RE: Constitution Storage Development; Full Spectrum Detention Pond Certification

Please accept this letter as formal documentation of conformance of the Full Spectrum Detention Pond (Pr. FSD-1) for stormwater quality and detention at the Constitution Storage Development. The Constitution Storage Development (Site) is located at 2460 Canada Drive, Colorado Springs within El Paso County, Colorado. The project site is located south of Constitution Avenue, west of Canada Drive, & east of Peterson Road. The site is located in a portion of Section 05, Township 14 South, Range 65 West of the 6<sup>th</sup> Principal Meridian, County of El Paso, State of Colorado.

# DETENTION BASIN OUTLET STRUCTURE DESIGN

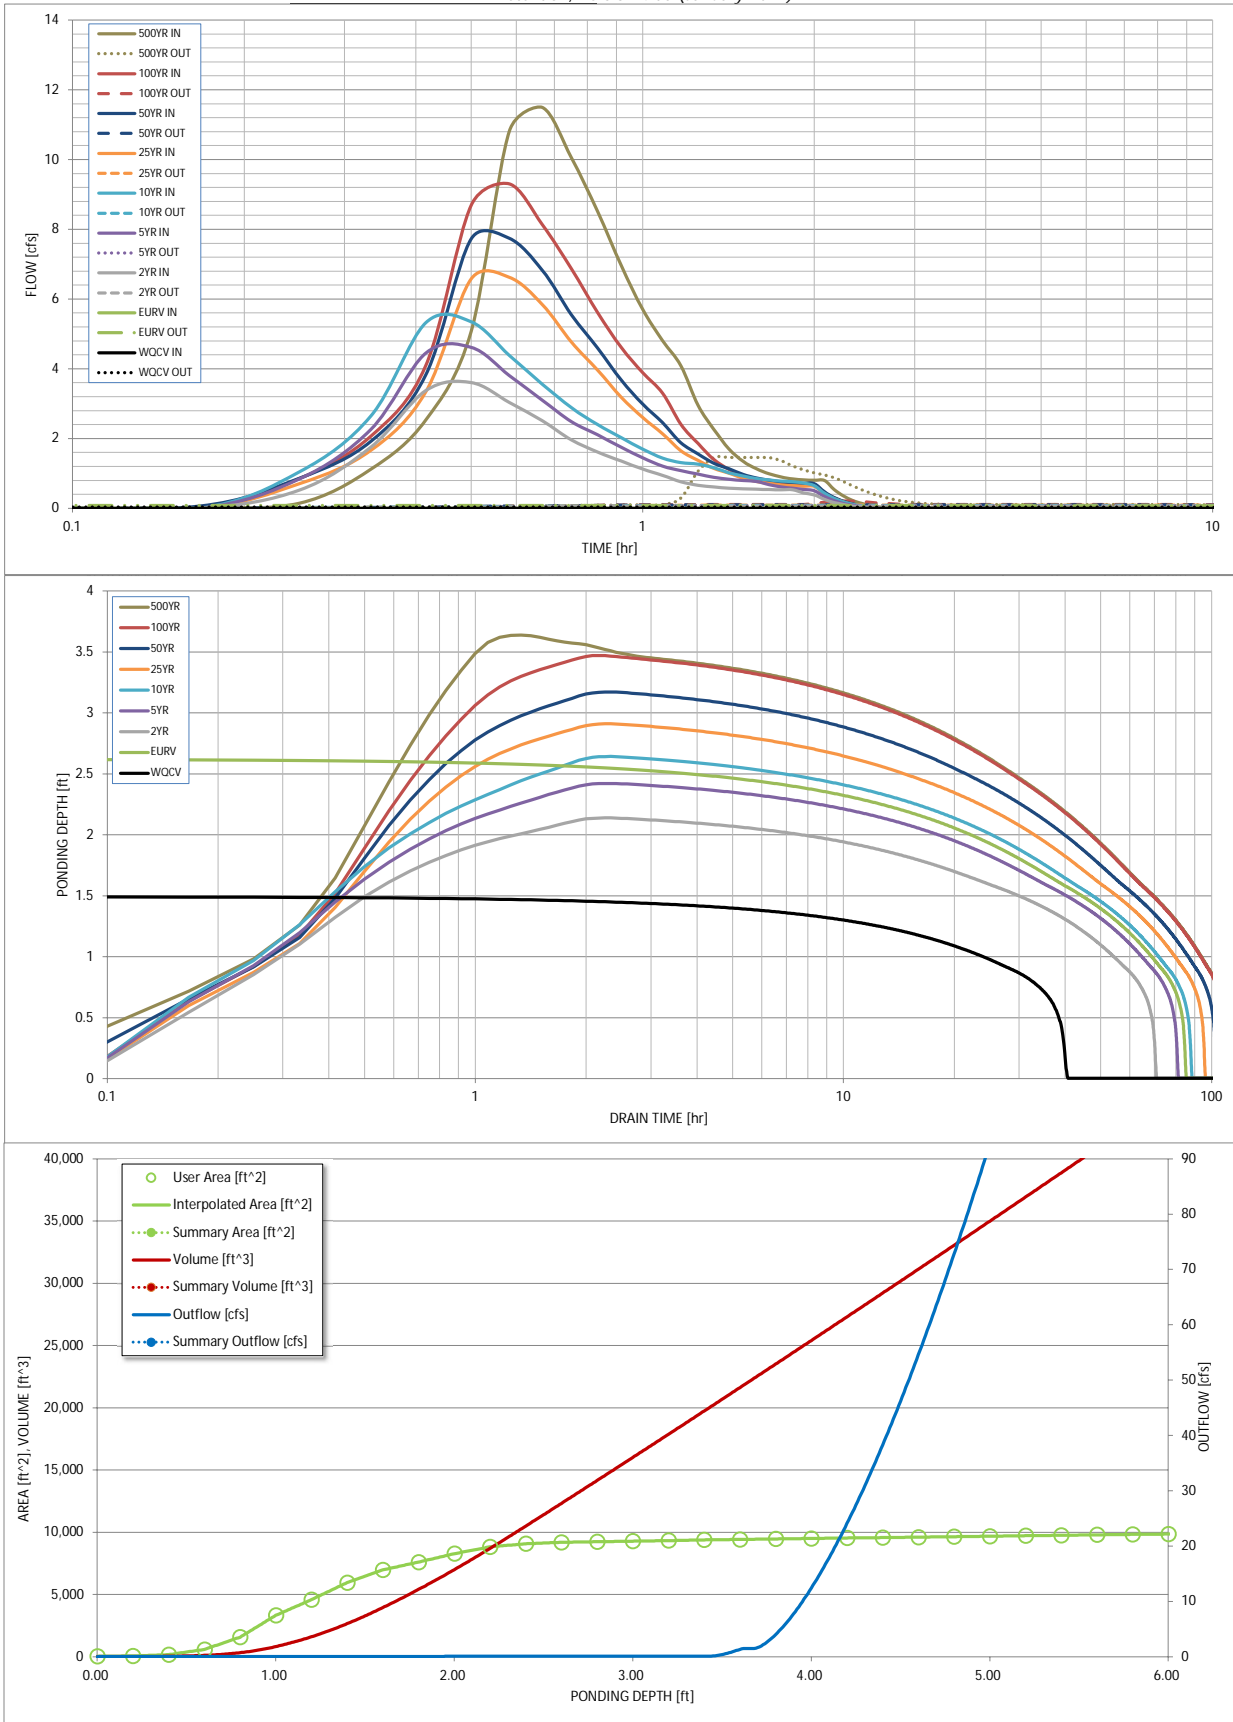
these numbers changed

these numbers didnt change

PPR2343 called for an 8" pipe. Please confirm
